*Ken Crawford
Retired Hydrogeologist
Former Principal Consultant
KLC Environmental Pty Ltd
October 2018*

Crawford Submission against the Vickery Extension Project

Vickery Extension Project Environmental Impact Statement Including Appendix C Flood Assessment

Figure 1 shows the extent of the Namoi floodplain between Carroll and Boggabri. Figure 1 Floodplain shown in red ie
landslope less than 2%

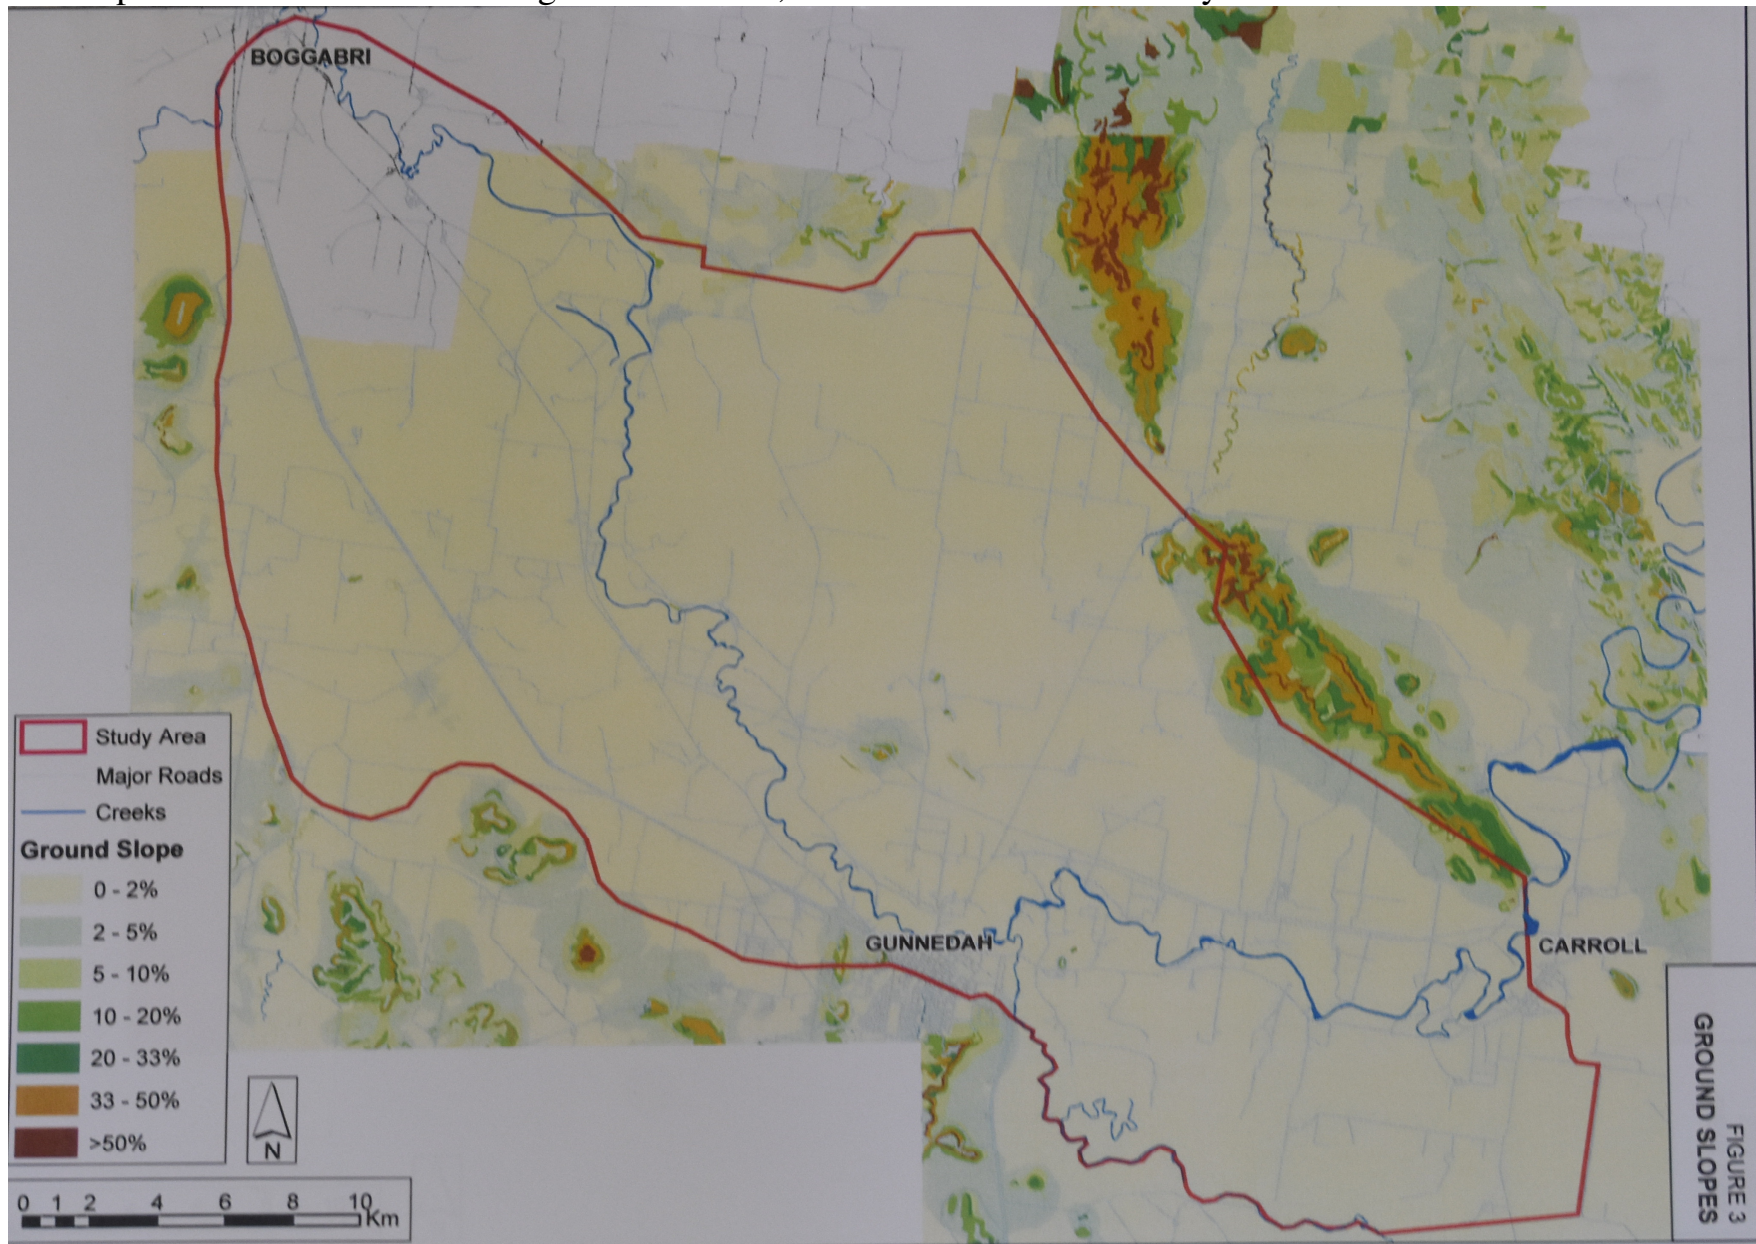
Coming back to the study area, we know from eye witness accounts that the floodway covers most of the floodplain in this area. This is confirmed by the Airborne Laser Survey (ALS) with 'draped over' hydraulic model representation of flood water depth (Webb, McKeown & Associates, 2005). see Figure 2

The locality and regional drainage characteristics map Fig 1.3 page 4 of the EIS Appendix C Flood Assessment can be superimposed over the floodplain maps in this submission. Using Gulligal Lagoon as a locating feature and the Namoi River on the eastern ridge side and Collygra Creek on the western ridge side makes orientation simple. Gulligal Lagoon is the crescent shaped feature coming off the Namoi River. Deadmans Gully is also a distinctive feature with it's sinuous nature and extensive flat floodplain.

Figure 2 Airborne Laser Survey (ALS) representing depth of flooding: from Carroll-Boggabri Floodplain Management Study

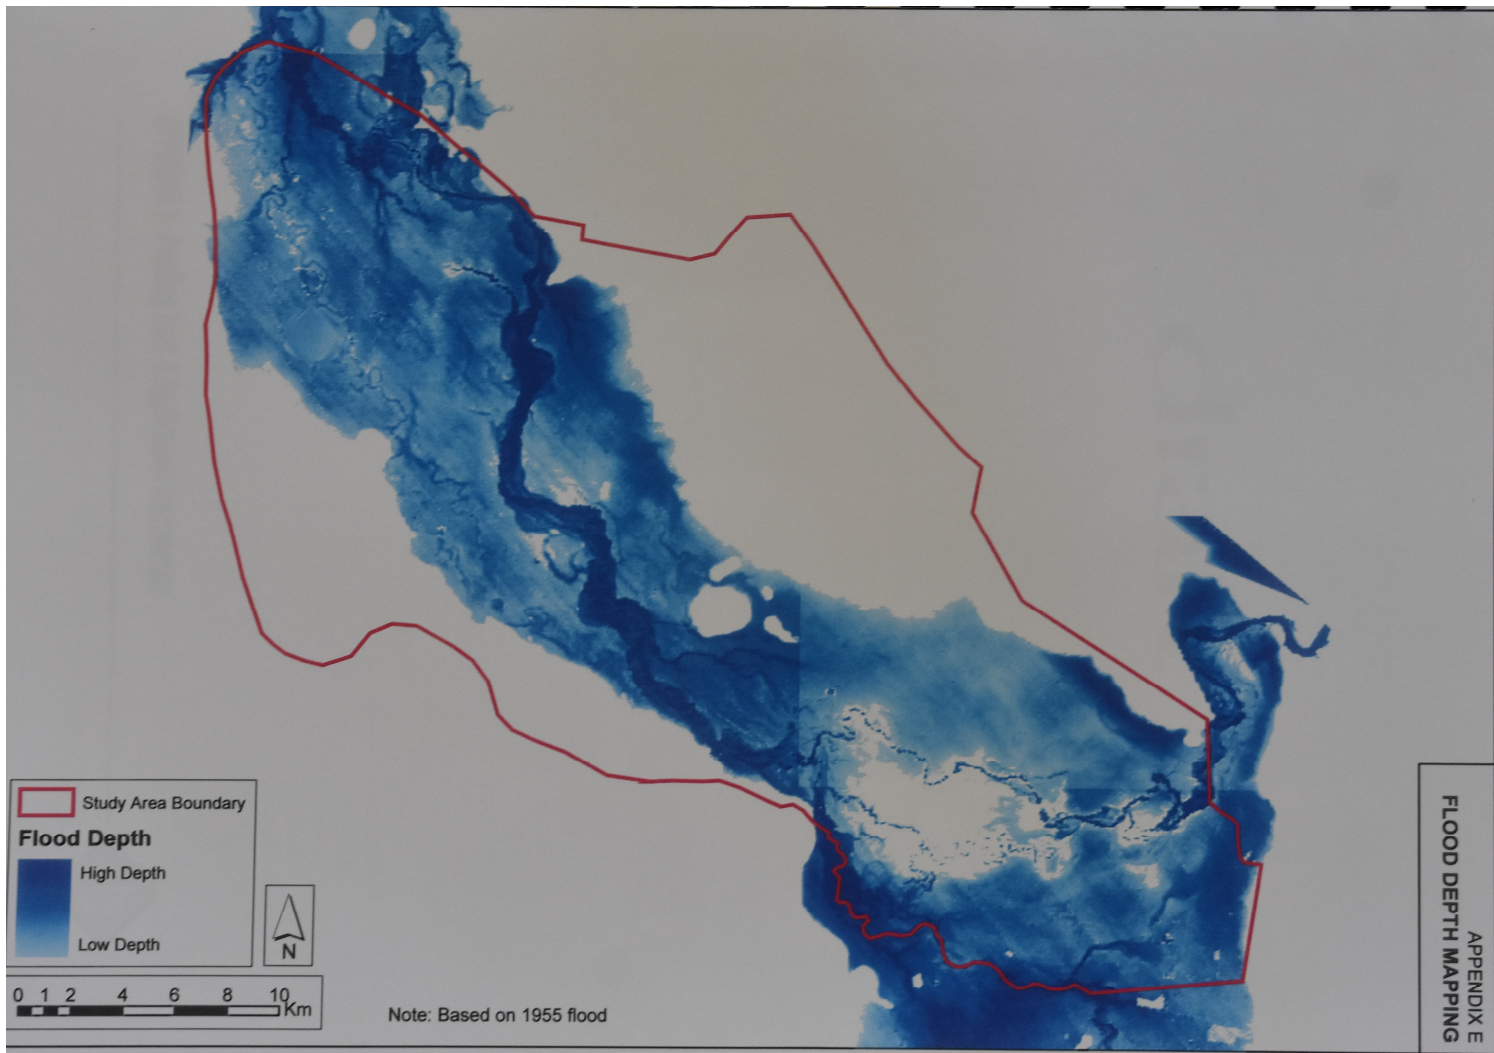
According to Webb, McKeown & Associates (2005), 'The Airborne Laser Survey (ALS) was also utilized as part of this study. The flood level results obtained from the hydraulic model were "draped" over the digital terrain model produced by the survey data to obtain a representation of the depth of flooding across the study area'. See Figure 2.

The implications of engineering structures across the floodplain include: potential erosive flooding causing soil erosion and reducing groundwater recharge, increasing stream bank erosion and ecological disconnection between river and floodplain.

Figure 1 Emerald Hill geological cross section Boggabri Irrigators Association/DLWC Regional Groundwater Review- Central Namoi Valley PPK Source of diagram Department of Water Resources (1991)

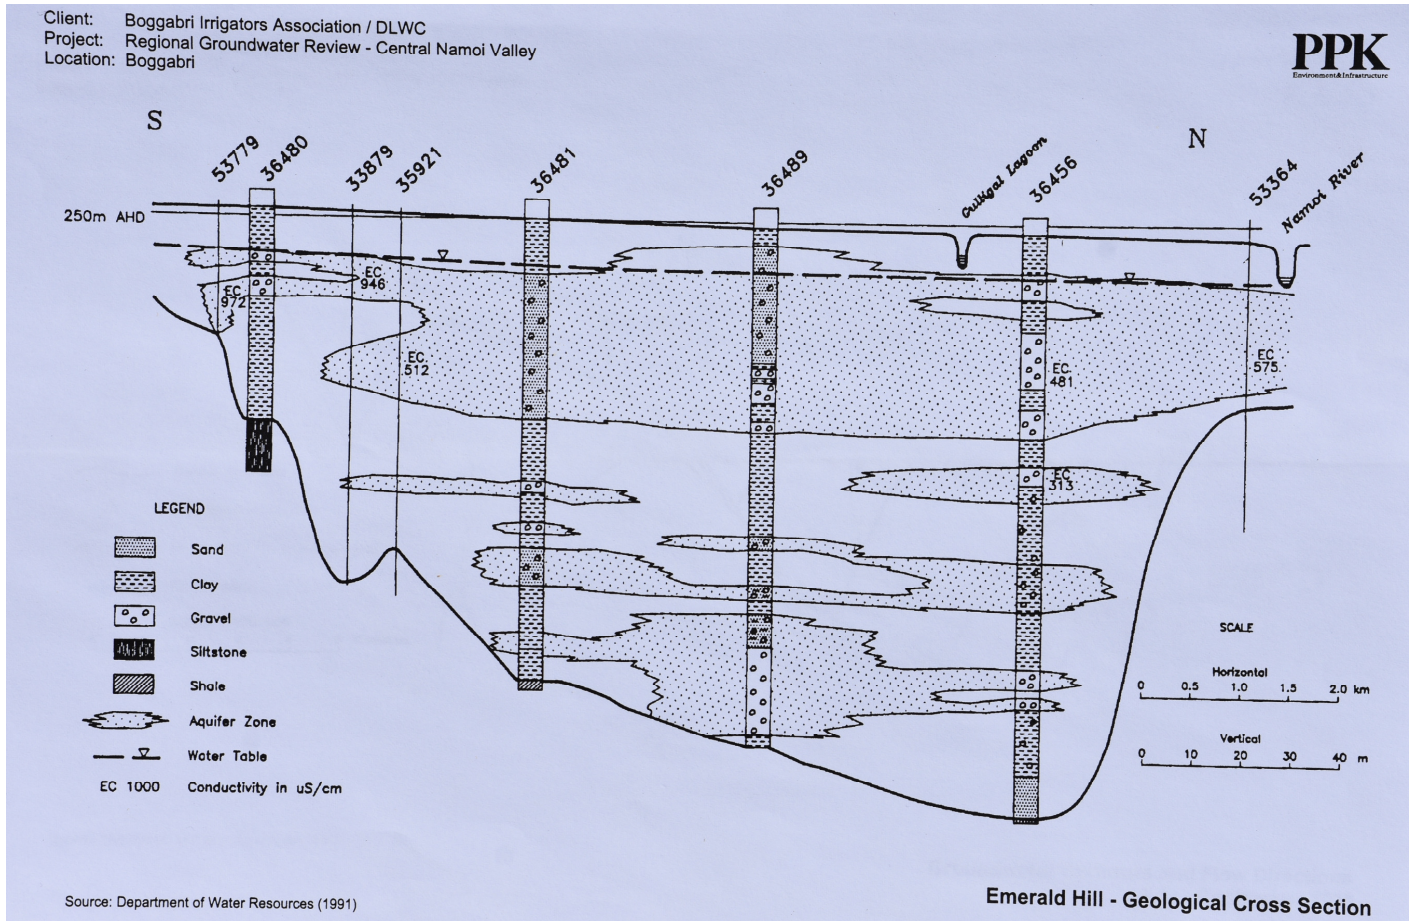
The Vickery Extension Project EIS railway location is directly across the main body of the floodplain over the deepest unconsolidated sediments of the alluvial aquifer. An understanding of sedimentology would rule out this railway loop because of poor location. The EIS fails to address this issue.

Compaction and subsidence results from, not only the initial pile driving of piers, but the long term continual vibration of heavy coal trains on the structure. The unconsolidated sediments of the alluvial aquifers in this area consist of the Narrabri Formation and the Gunnedah Formation. Gravels, sands and clay aquitards containing precious groundwater exist in this hidden valley Figure 1: Geological cross-section Emerald Hill to Namoi River.

The pore space containing the precious groundwater varies from approximately 60-65% by volume in the Gunnedah formation. These aquifers can be interfered with by way of reducing recharge and reducing the storage capacity of the pore space in the unconsolidated alluvial sediments. It happens imperceptibly over time. The continual vibration causes a 'preferred orientation' of the sediments. They take up less space meaning that aquifers may not refill to the same extent. Aquifer storage capacity is reduced. This a high risk to GW Zone 4 west which the proposed railway-loop divides in two.
